Reviewed by
dsdgrimm
04/23/2019 5:56:30 PM

**Final Drainage Report
Rocky Top Resources
Tract 7 Valley Garden Subdivision
1755 East Las Vegas
El Paso County, Colorado**

Kiowa Project No. 17066
March 26, 2019

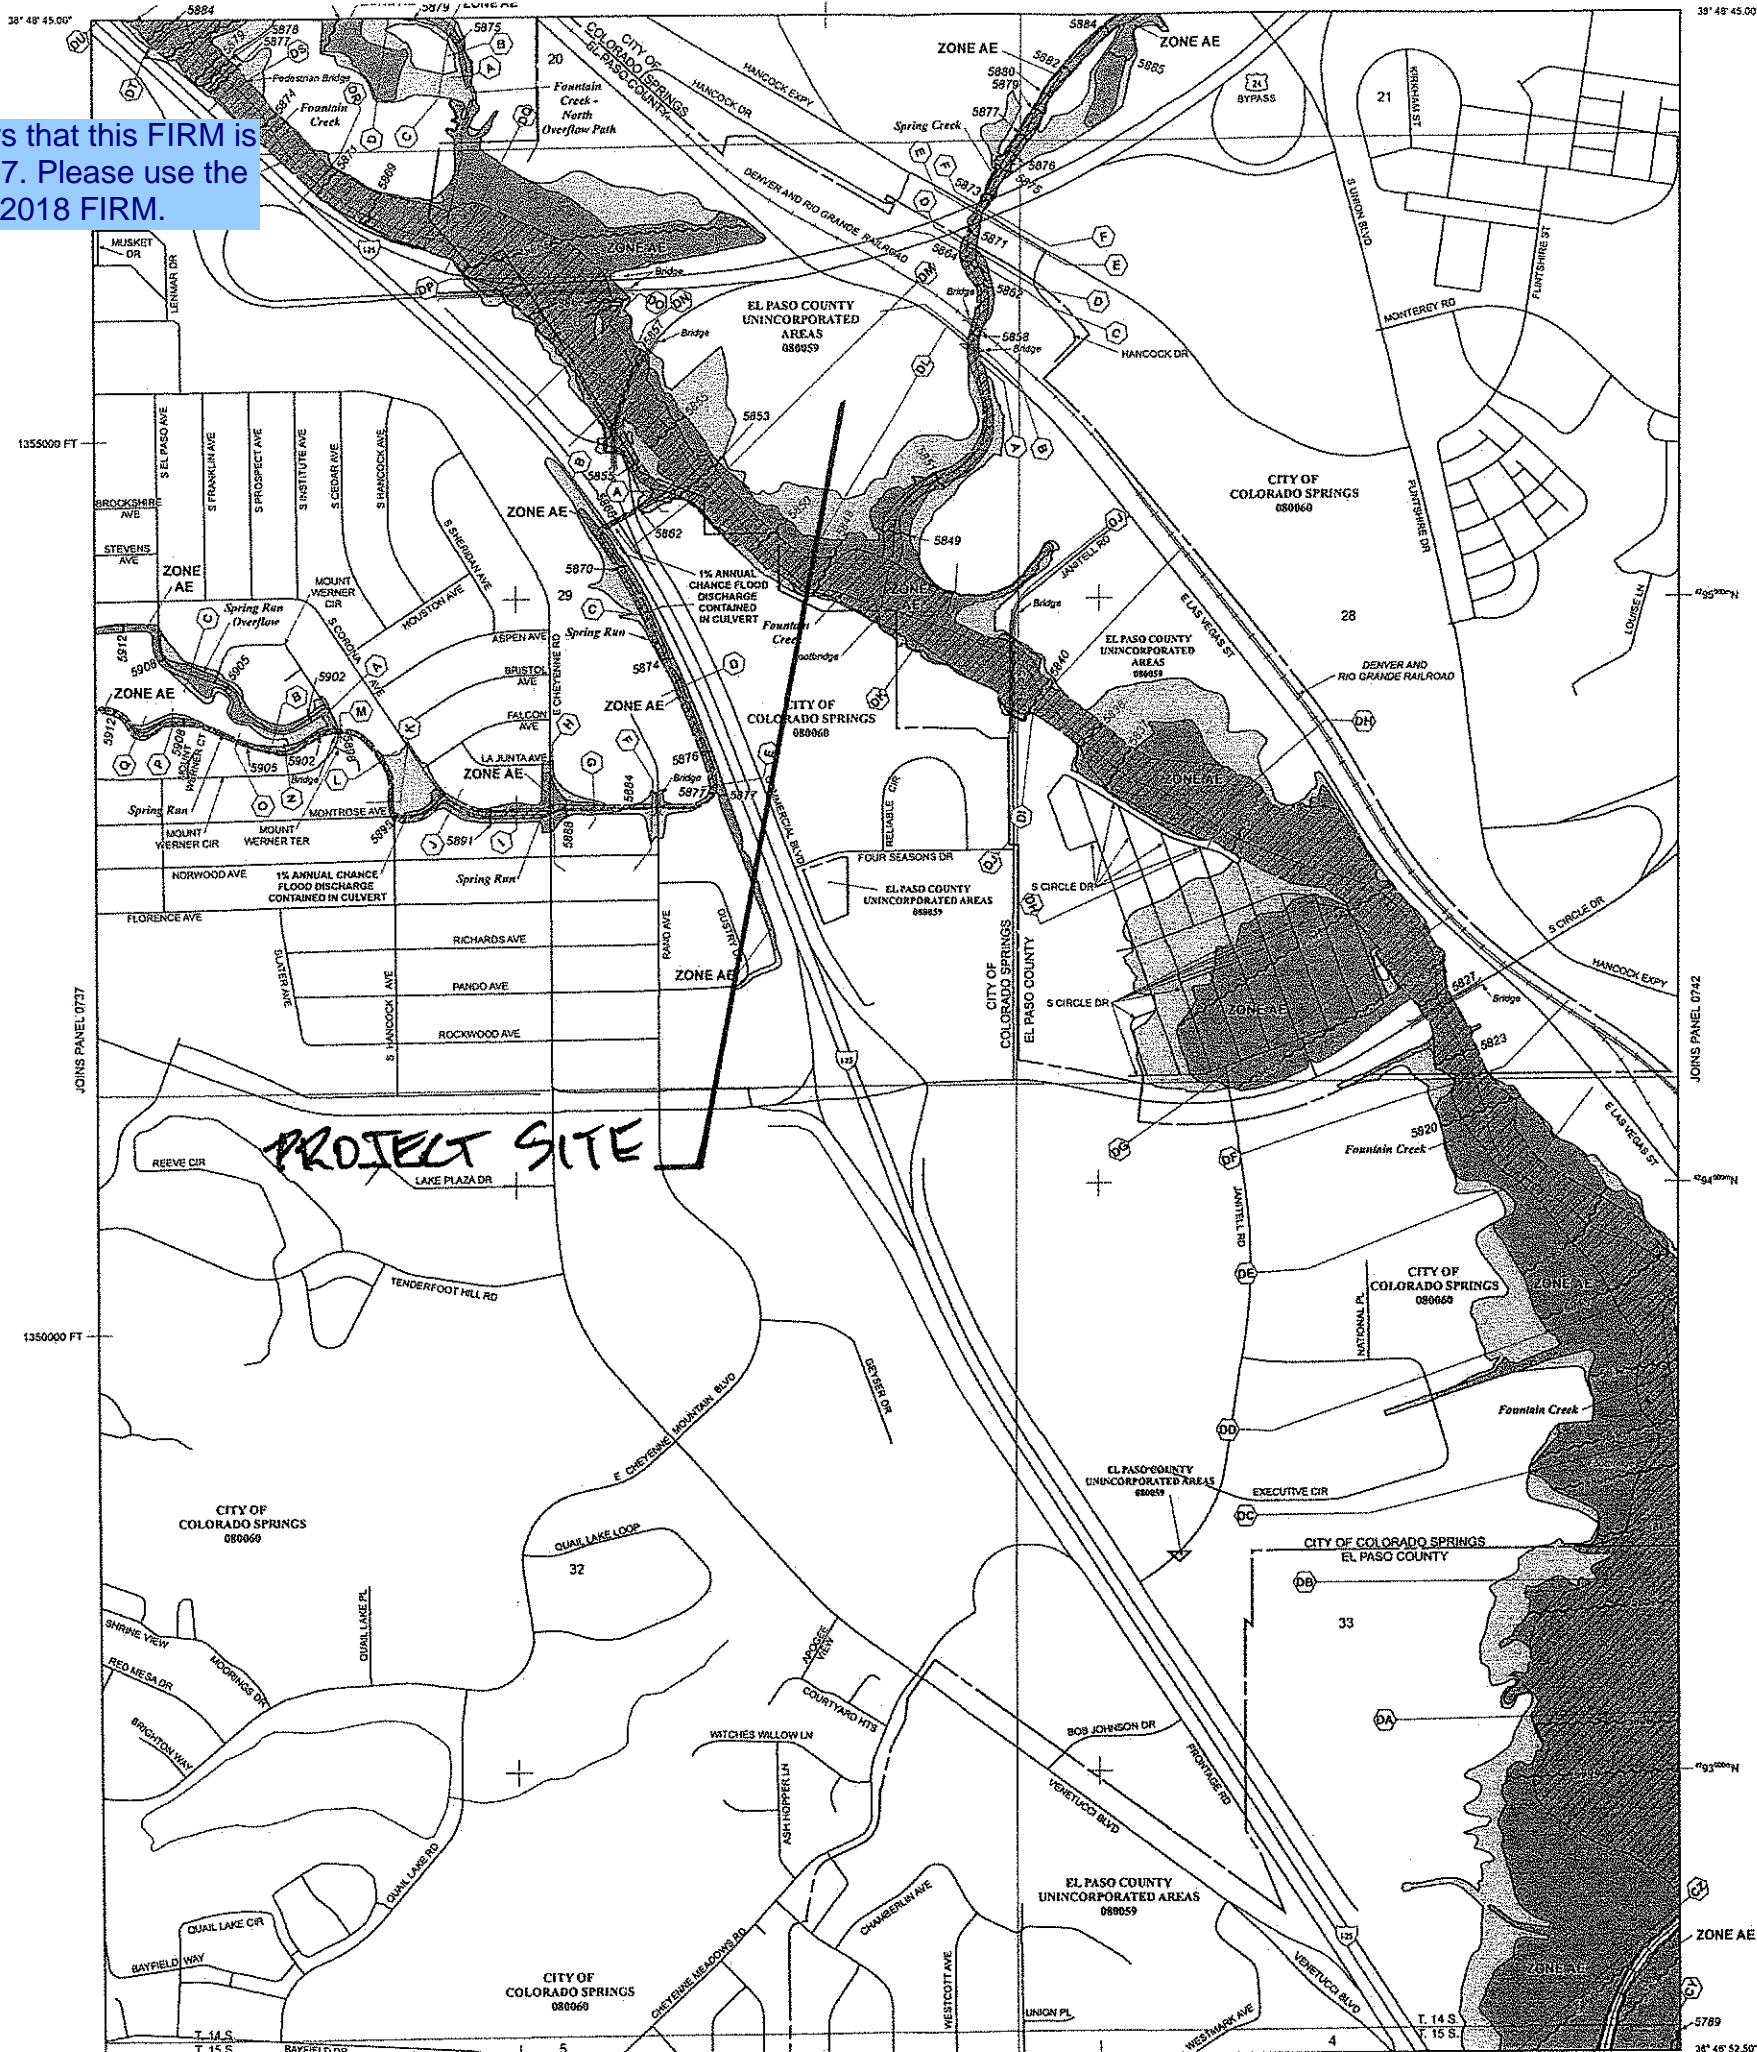
It appears that this FIRM is from 1997. Please use the updated 2018 FIRM.

CLIENT Rocky Top Reservoir
PROJECT _____
DETAIL EDB Stage/Storage

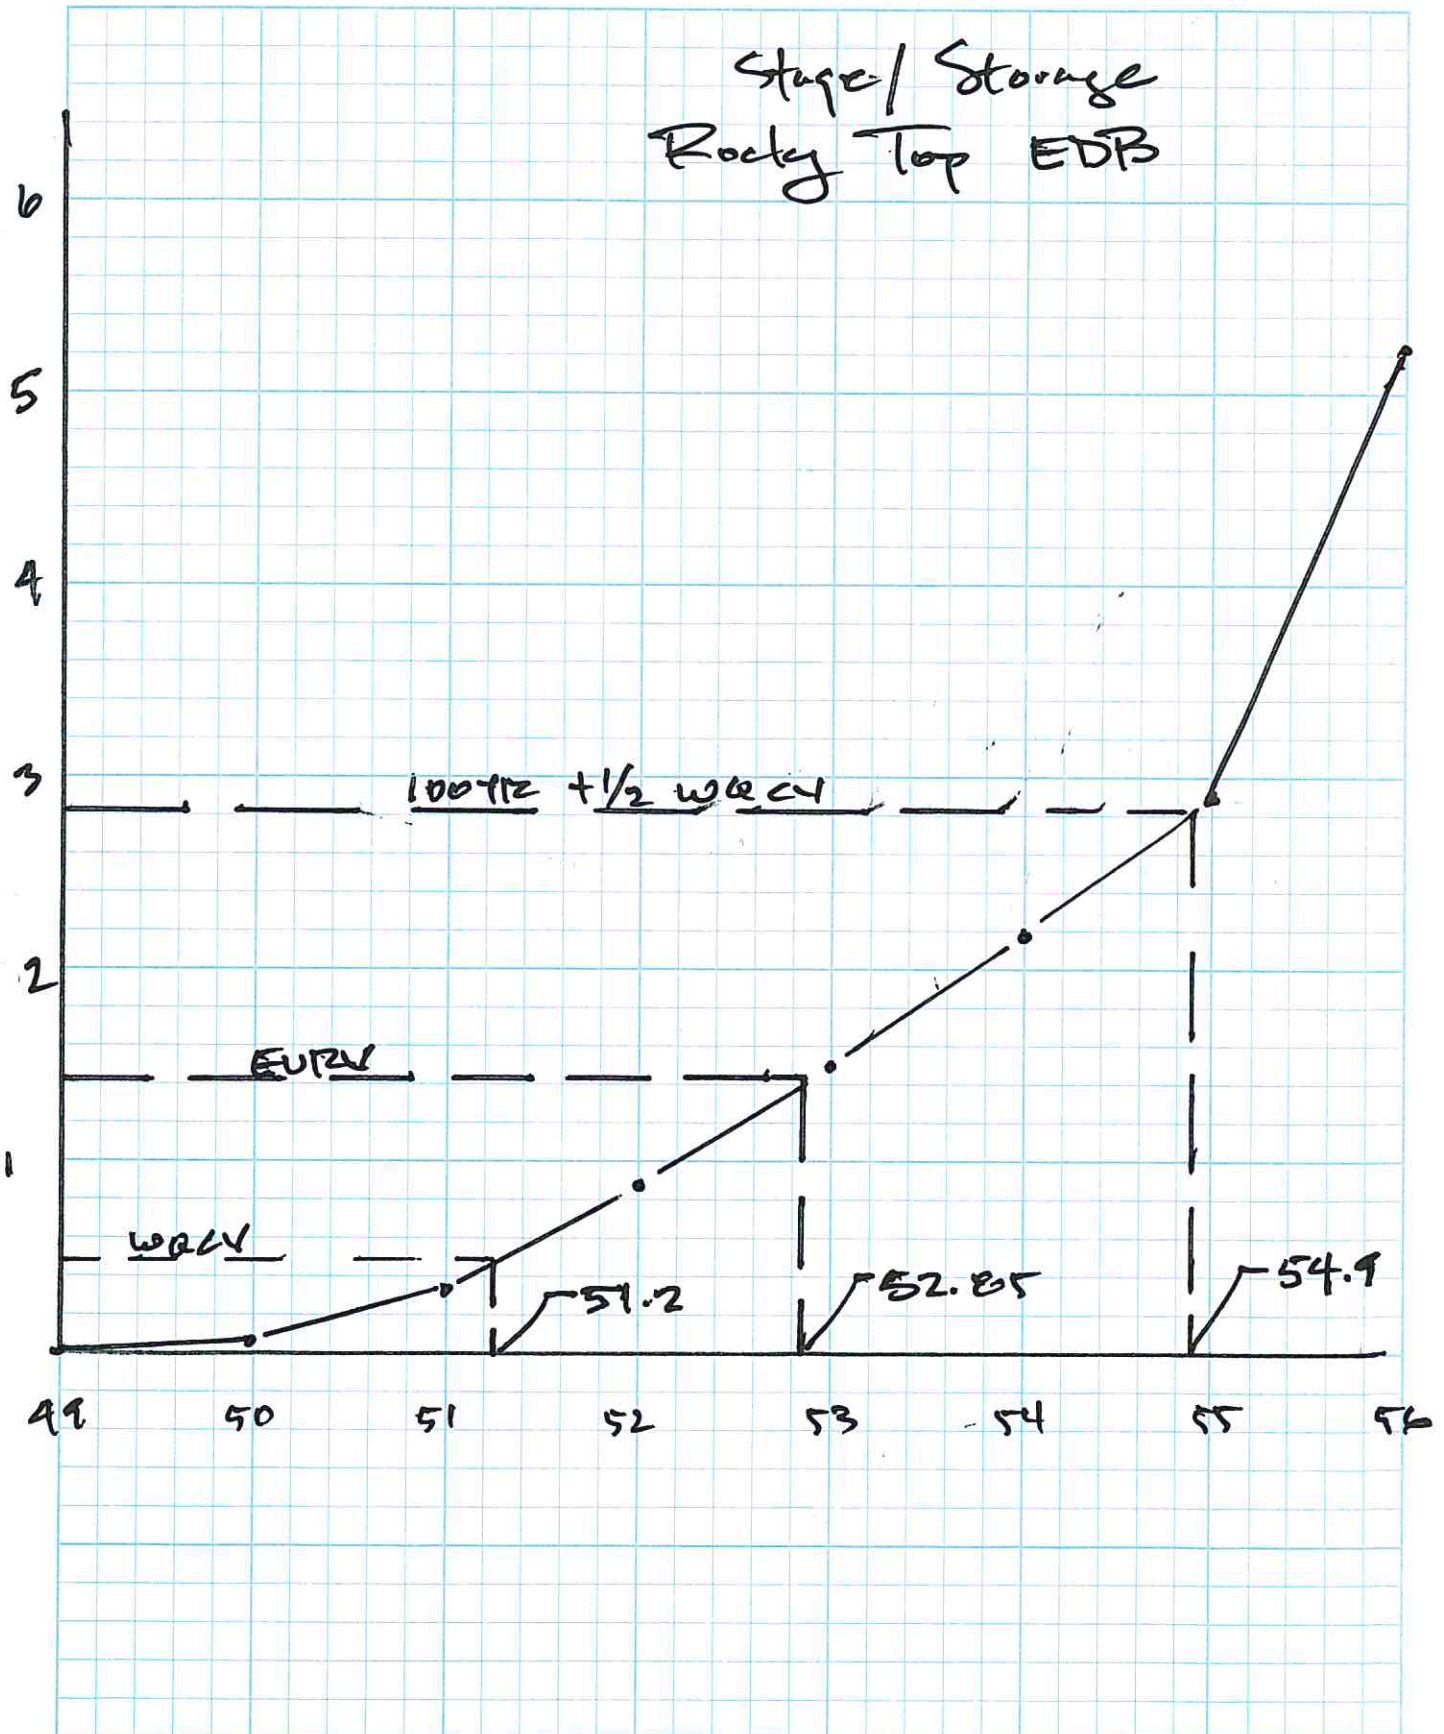
Provide the UD Spreadsheet calculations for the outlet structure.

ROCKY TOP RESOURCES
PROPOSED DRAINAGE PLAN
TRACT 7 VALLEY GARDEN SUBDIVISION
1755 EAST LAS VEGAS STREET
COLORADO SPRINGS, COLORADO

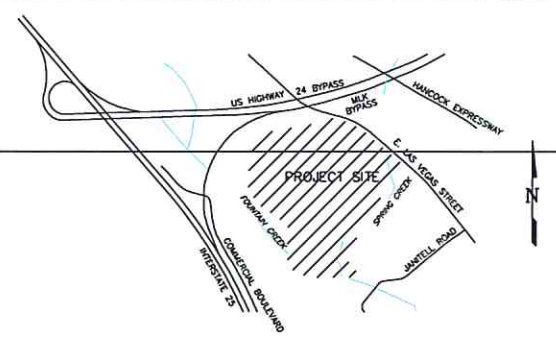
Where are the flow paths for Basin 1 and 4 located on this map? Please provide.
